Medway Design Review Committee Meeting
Monday, February 06, 2023
Zoom (Remote) Meeting

Project Review – 7 Sanford Street Multi-Family Special Permit Application

Medway Commons Site Plan – Chipotle and Starbucks, 67B and 67C Main Street

Milford Regional Hospital Medical Facility Master Signage Plan – 86 Holliston Street-

② Proposed South
1/8" = 1'-0"

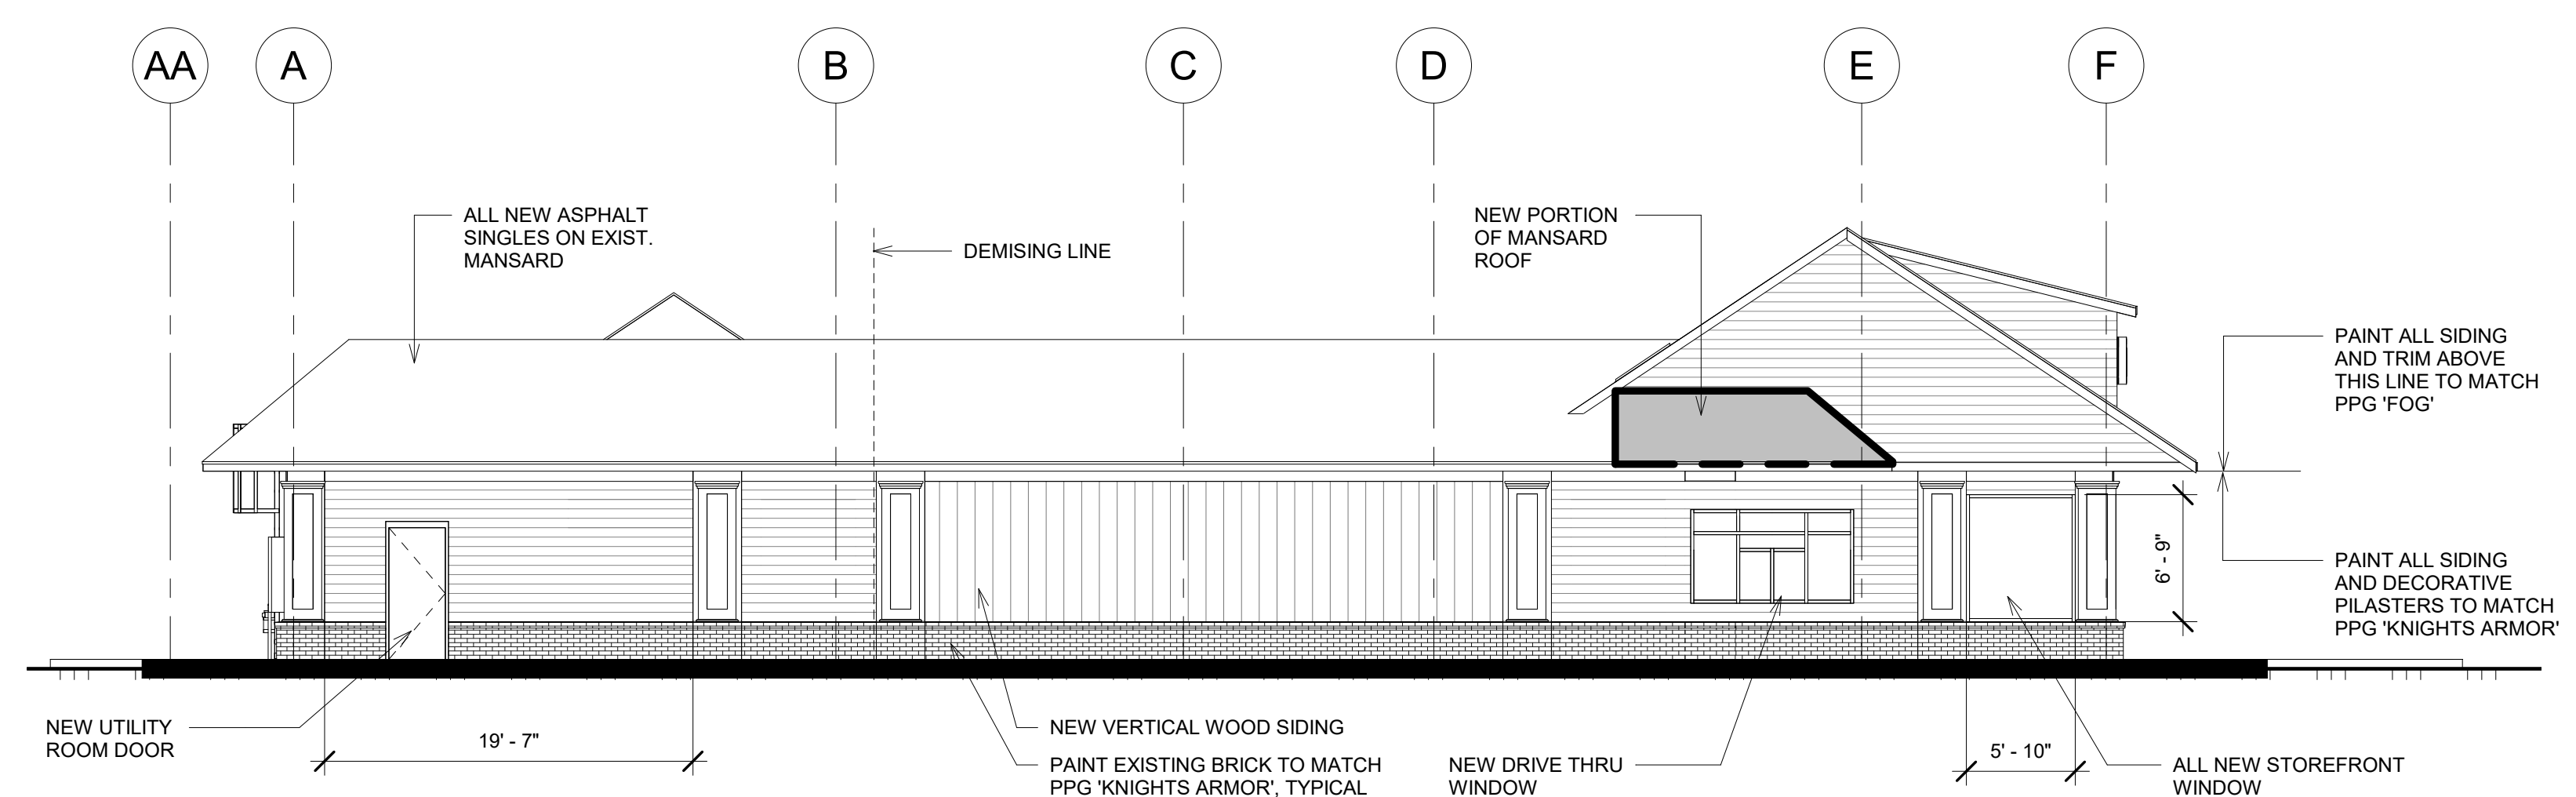
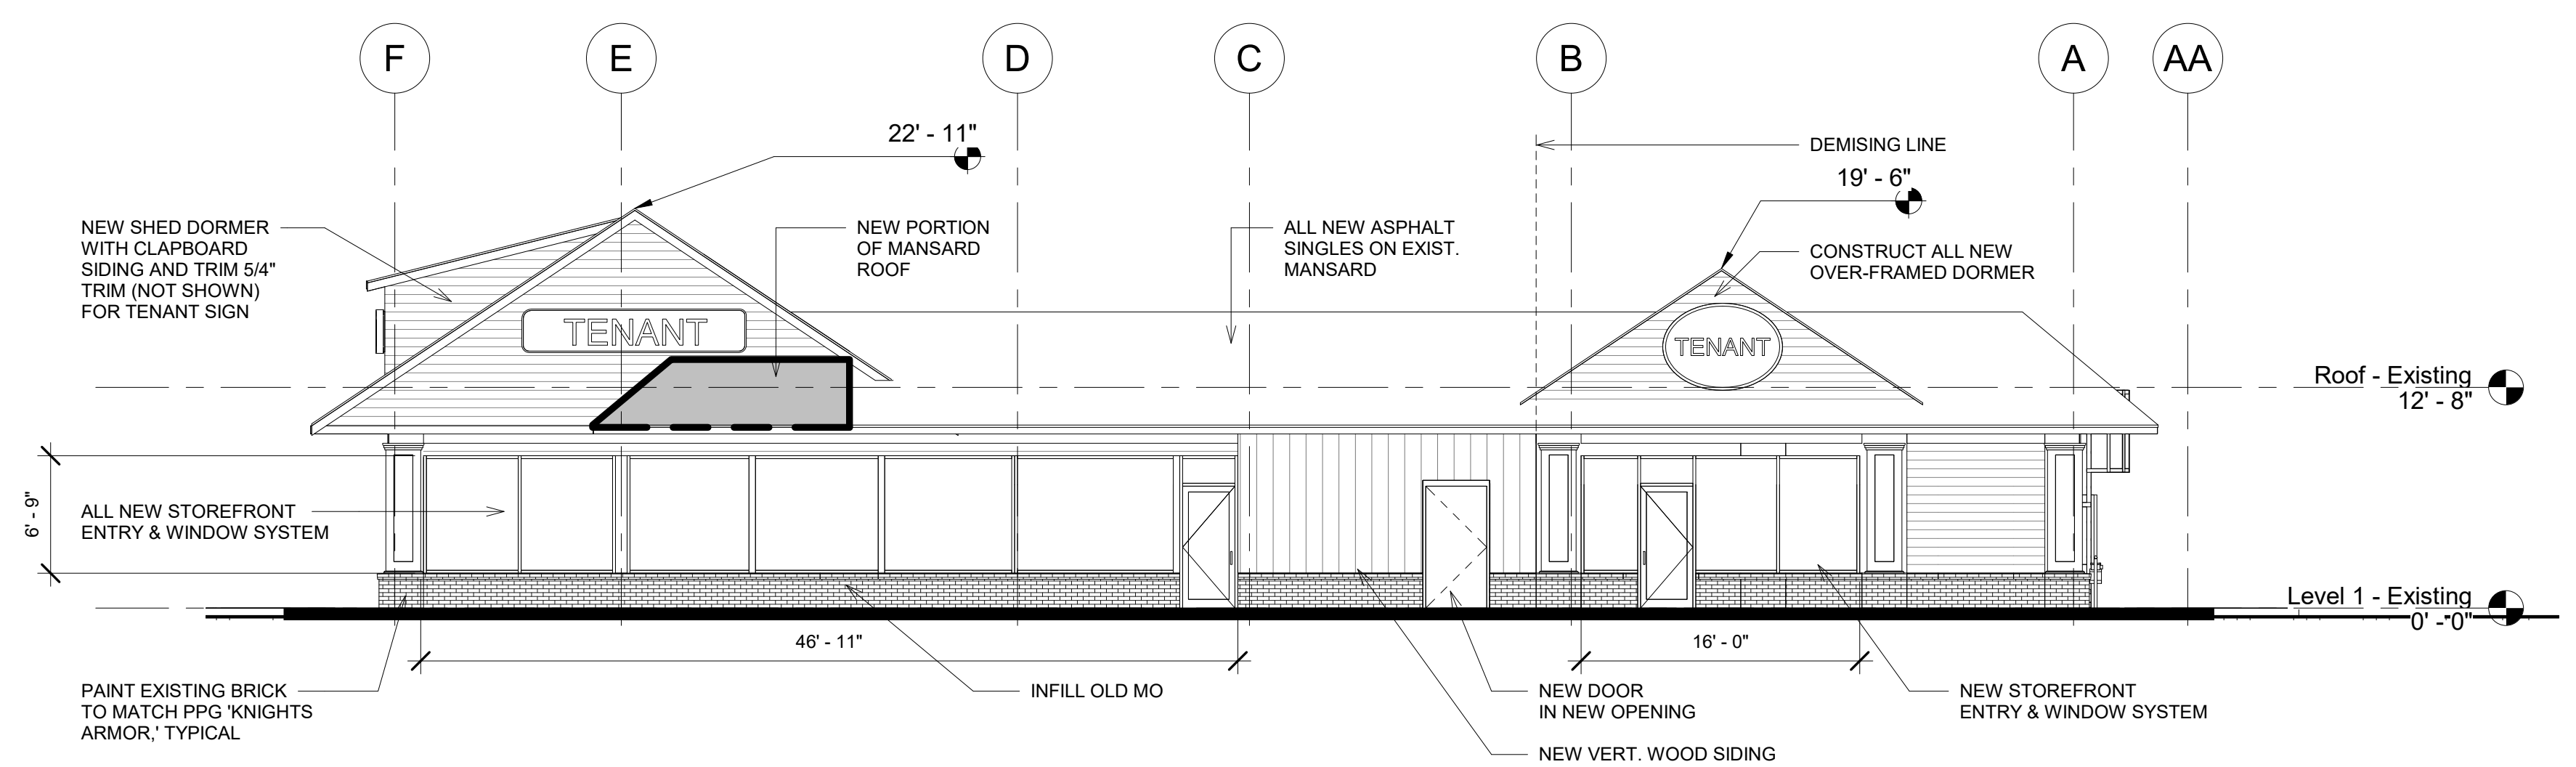
Proposed street views were shown and discussed with the members. Mr. Buckley asked about the roof ladder on the west elevation. It was mentioned that it's a necessity to provide safe and OSHA compliant access to the roof. The frequency of the access will be regular between the tenant and owner's needs for maintaining the building's HVAC systems including the roof. There was discussion on making some visual and design improvements to prevent the split in the mansard. A

screen/ panel like structure on top of the ladder was suggested to fill the gap between mansards. Ms. Johnson reminded that safety should not be compromised which could potentially occur with the presence of a screen at that location.

Site Plan Modifications

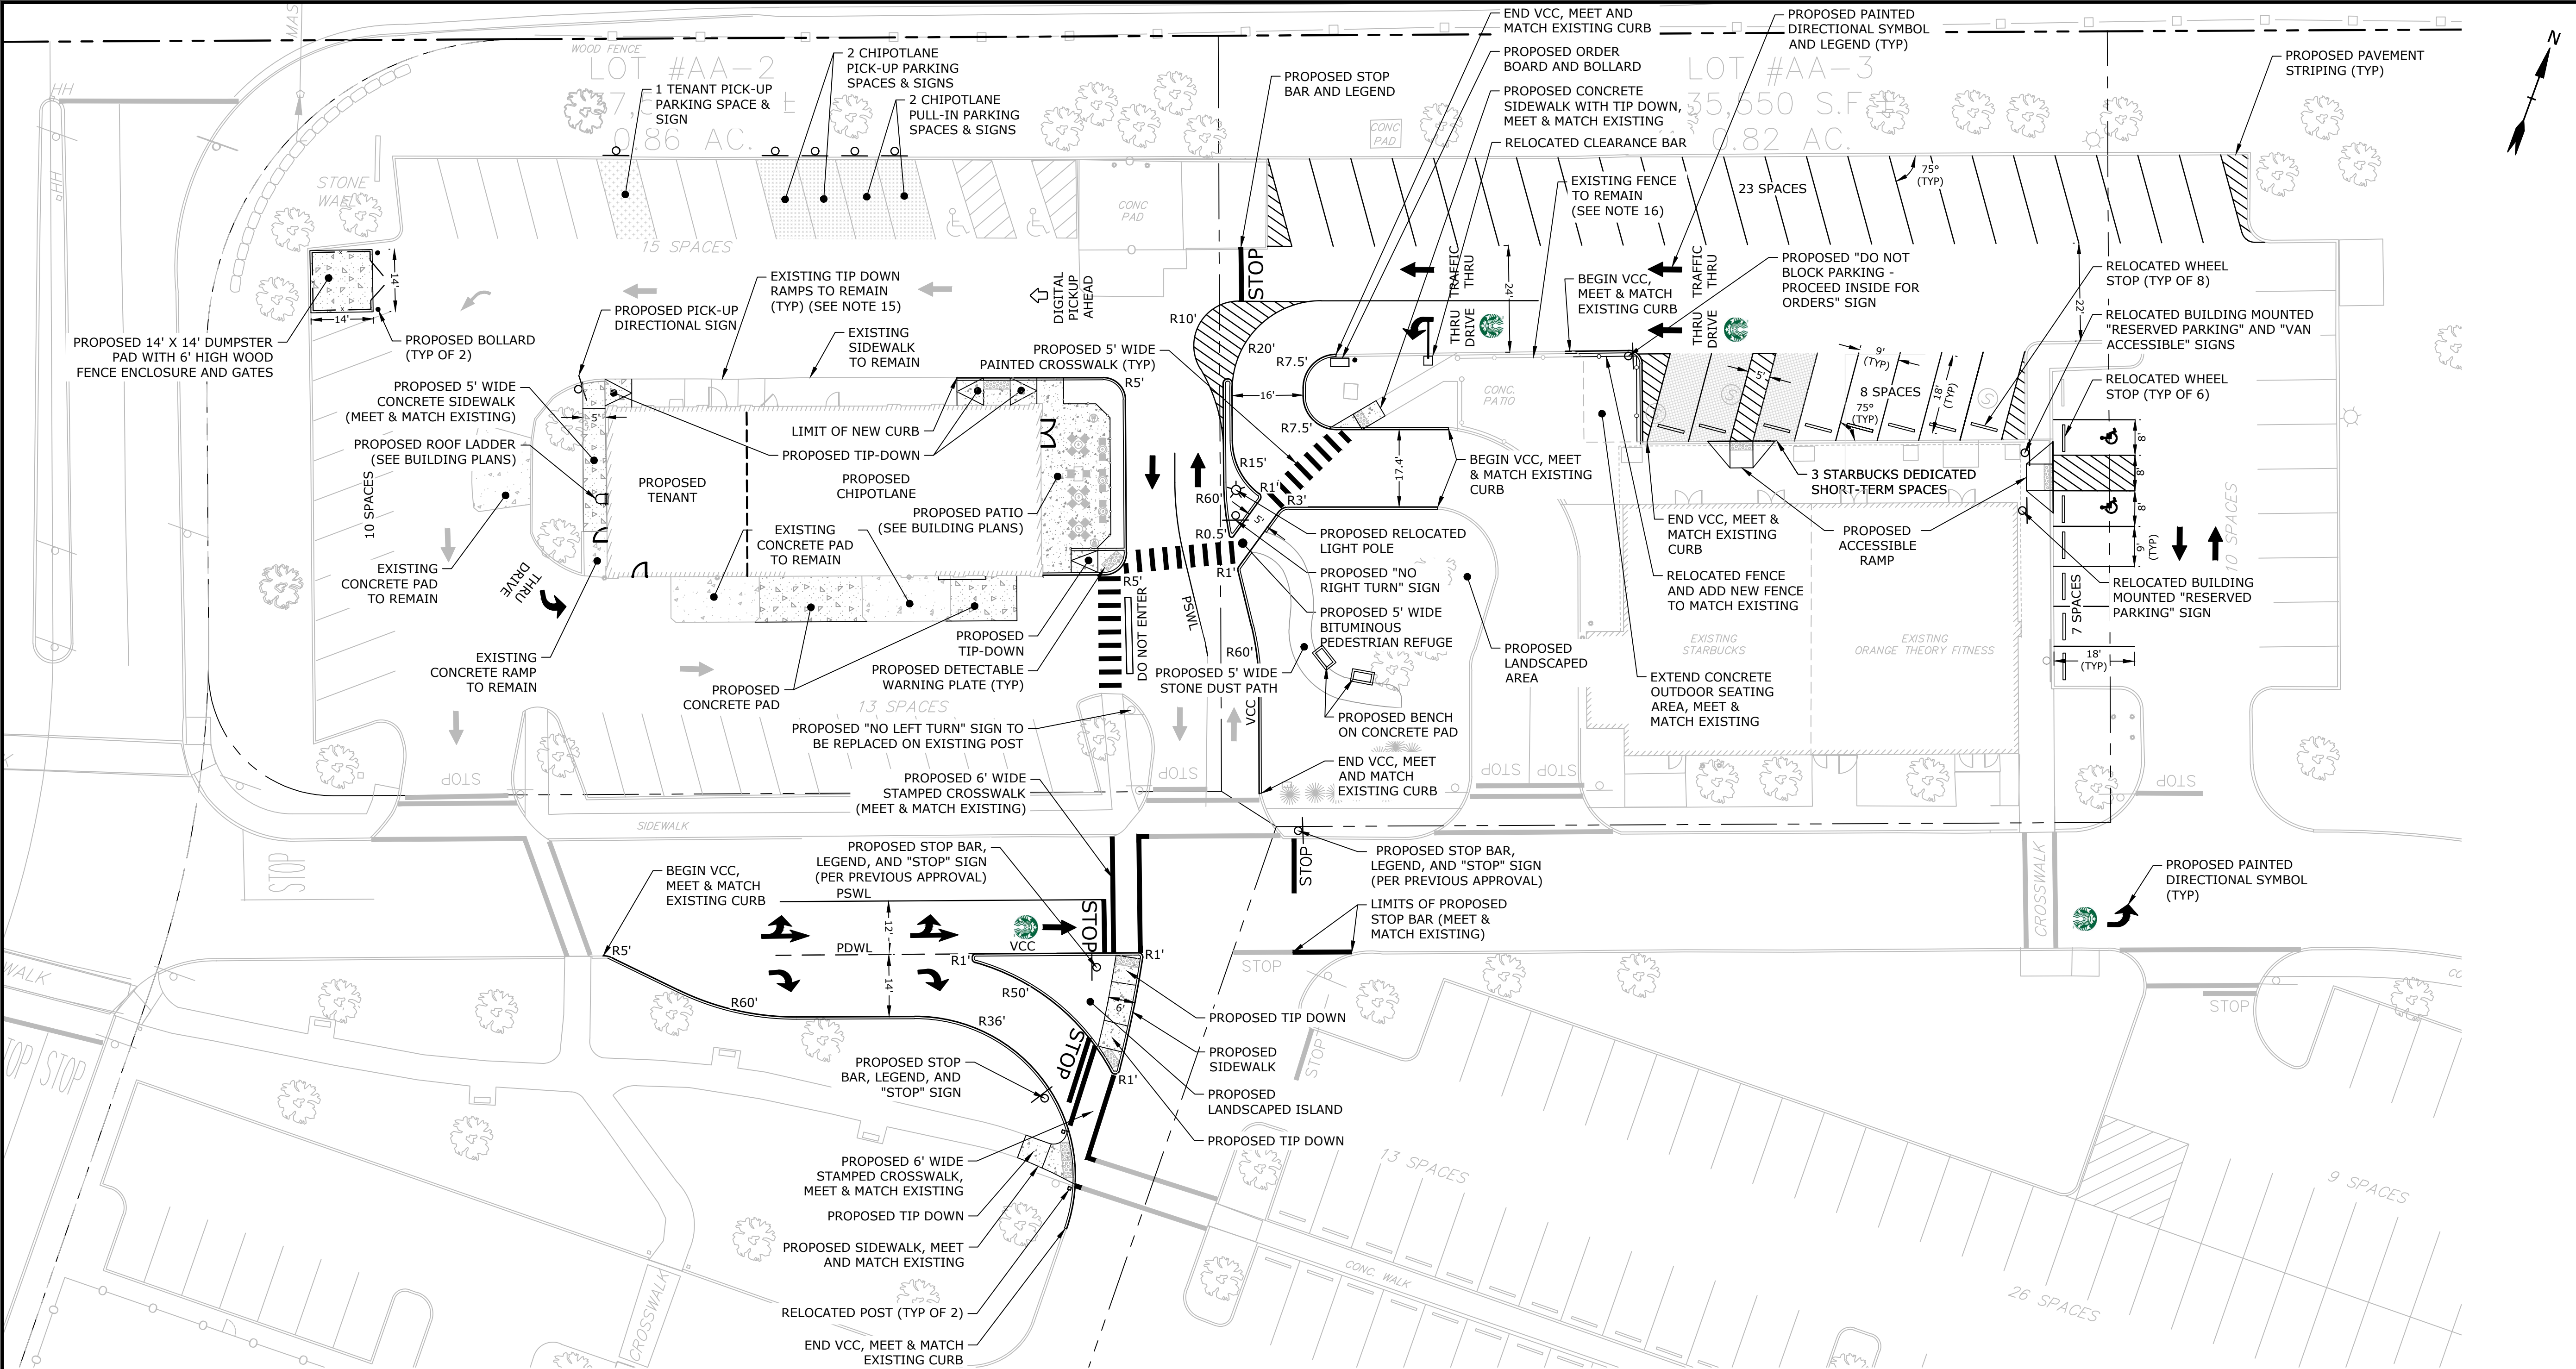
Ms. Affleck-Childs suggested adding some supplemental landscaping in the area closer to the proposed dumpster enclosure. Applicant agreed to investigate it. It was suggested the final site plans should include details on the final landscaping and the proposed sitting area. To a question on the status of developing a master signage plan for Medway Commons, Ms. Johnson said they're currently working with the sign designer. Ms. Affleck-Childs mentioned that Ms. Johnson had prepared a narrative outlining how the current design is reflective of the Design Review Guidelines. She said this is being asked of all site plan applications. The PEDB hearing for the special permit will be on Feb 14th. The DRC's review letter to the PEDB will be drafted by Ms. Clifford.
